[\[EDITOR's NOTE from 1772b-I2C-contrib-bwy-v9-FINAL to this document v10. – DELETE after presentation to IEEE 1722.\]](#)

9.4.16. I2C message

IEEE P1722b Draft 1.8 Contribution – I2C
IEEE Standard for a Transport Protocol for Time-Sensitive Applications in Bridged Local Area Networks

Figure 79 -- I2C Bus and Agent Request: Response Examples

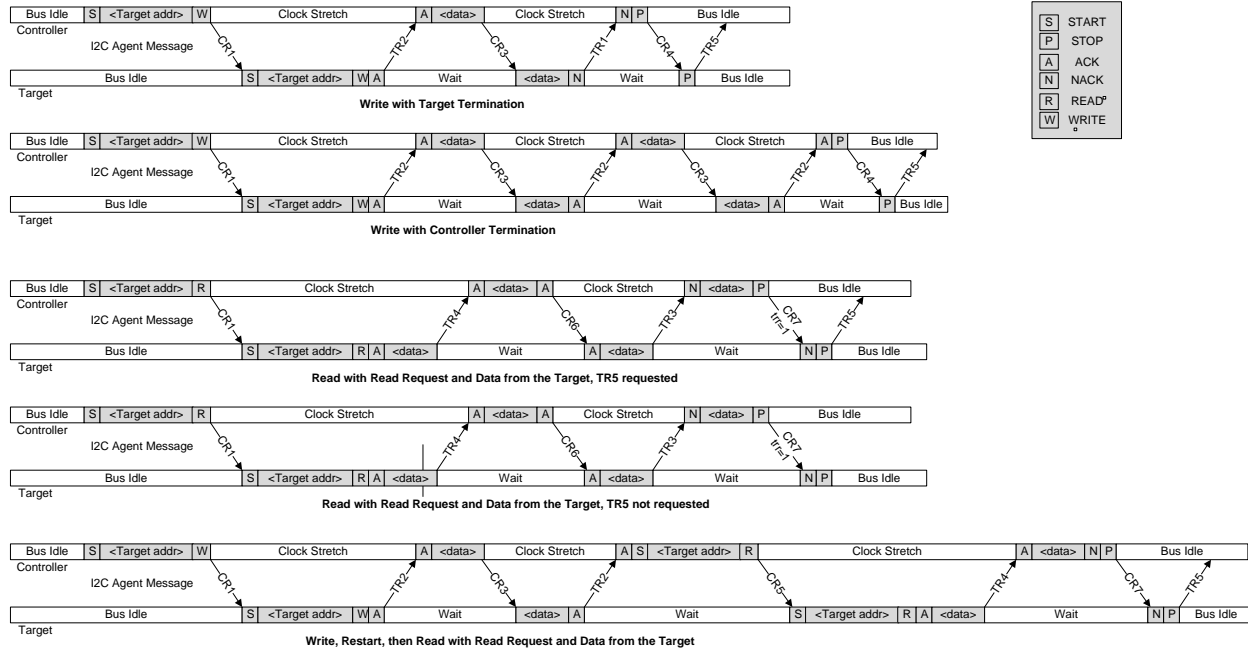
[2. Two types of read – read with early \(ack\) response and read with ack and data response are the controller's choice with no clear benefits for having the two variations. Remove read with early \(ack\) response to simplify operation.](#)

[Consequence: In Table in 9.4.16.19, the variable "RR" is replaced with "1", and references to "early response" operation in text is deleted. And Diagram in the same sub-clause revised.\]](#)

Blank space indicate don't care. ~~The variable RR (Read Request) used on rd field may be set to a one (1) if a read operation with Target's early response is indicated, or set to a zero (0) if a read operation with Target's response to a read request is indicated.~~ When the Read Request is indicated from the Controller Agent's request, the Target Agent's response will be returned with the first byte of read data. The Figure 79 illustrates ~~representative bus transactions both an early response and a read request.~~
